SERVICE BULLETIN

292 73 2096

ARRIEL 2 B - B1 - C - C-PM - C1- C2 - S1

Subject : Adjusted fuel valve assembly. Start electro-valve with improved internal seal.

ANNEXE 1 / APPENDIX 1

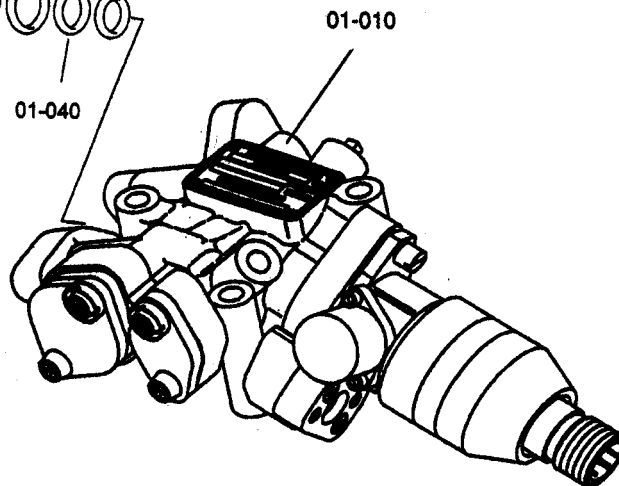
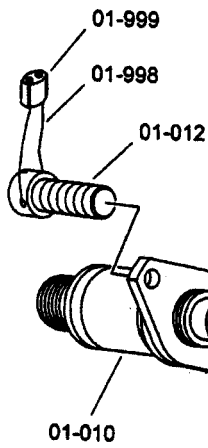
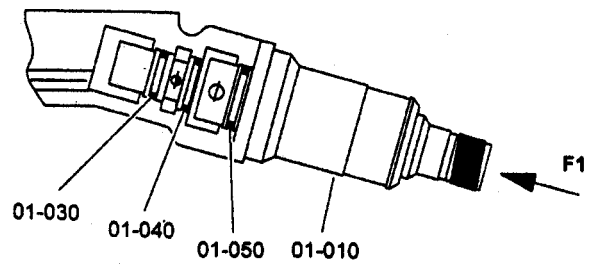
Marquage provisoire de la plaquette d'identification Temporary marking of the identification plate

Rayer les quatre derniers chiffres de la référence.

Engrave a line through the last four numbers of the Part Number.

Marquage des quatre derniers chiffres (2096) du Service Bulletin identifiant l'application de la modification TU 96.

Engrave the last four numbers (2096) of the Service Bulletin referencing modification TU 96.

Engrave using a vibro pen.

Height of the numbers: 1.5 mm
